Access Compliance Report

Public Rights-of-Way

(Curb Ramps)

Intersection ID: 31347	Main Street: MICHAW_CT	Cross Street: OAK_PASTURE_LN	Location: SW
ADA ID: 9373A81C3AB9	Ramp Type: PerpDiag	Initial Pass/Fail: Fail	Overall Compliance: No
Severity Score: 30			
Codes/Mitigation Info/Possible Solution		Field Measurements/Component Compliance

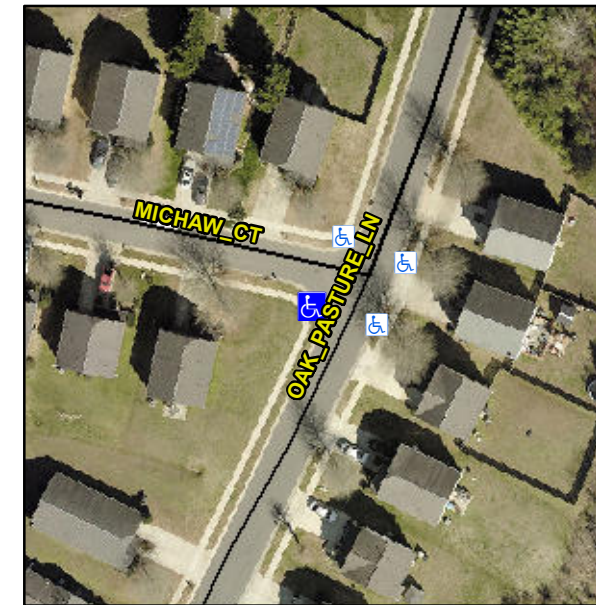
Not Found, R304.5.1, R304.2.2

Compliance	Description	Data	Compliance	Description	Data
N/A	Ramp Length (in)	49.0	No	Ramp Slope (%)	11.9
No	Ramp Width (in)	35.0	Yes	Ramp XSlope (%)	0.8
N/A	Flare Type LT	N/A	N/A	Flare Type RT	N/A
N/A	Flare Slope LT (%)	N/A	N/A	Flare Slope RT (%)	N/A
N/A	Flare Traversable LT?	N/A	N/A	Flare Traversable RT?	N/A
N/A	Landing Length (in)	N/A	N/A	DWS Provided?	N/A
N/A	Landing Width (in)	N/A	N/A	DWS Contrast?	N/A
N/A	Landing Slope (%)	N/A	N/A	DWS Length (in)	N/A
N/A	Landing X Slope (%)	N/A	N/A	DWS Full Width?	N/A
N/A	Landing Curb? (Y/N)	N/A	N/A	DWS Offset (in)	N/A
N/A	Shared Landing?	N/A			
N/A	Gutter Ponding?	N/A	N/A	Gutter Slope (%)	N/A
N/A	Gutter Lip Ht (in)	N/A	N/A	Gutter X Slope (%)	N/A
N/A	Painted X Walk1?	No	N/A	Painted X Walk2?	No
	X Walk 1 Direction	To E		X Walk 2 Direction	To NE
N/A	X Walk 1 Width (in)	N/A	N/A	X Walk 2 Width (in)	N/A
	X Walk 1 Slope (%)	0.9		X Walk 2 Slope (%)	1.3
	X Walk 1 X Slope (%)	1.2		X Walk 2 X Slope (%)	3.3

N/A	Ramp inside XWalk1?	N/A	N/A	Ramp inside XWalk2?	N/A
	Road Slope (%)	2.0	N/A	Clear Space?	N/A
	Road X Slope (%)	1.0	N/A	Clear Space to XWalk (in)	N/A
N/A	Any Obstructions?	N/A	N/A	Storm Grate/Utility Hazard?	N/A
	Obstruction Type			Storm Grate/Utility Type	
		N/A			N/A
			Yes	Surface Condition? (G/P)	Good

Remove & Replace Curb Ramp With Two New Directional Ramps or Equivalent.
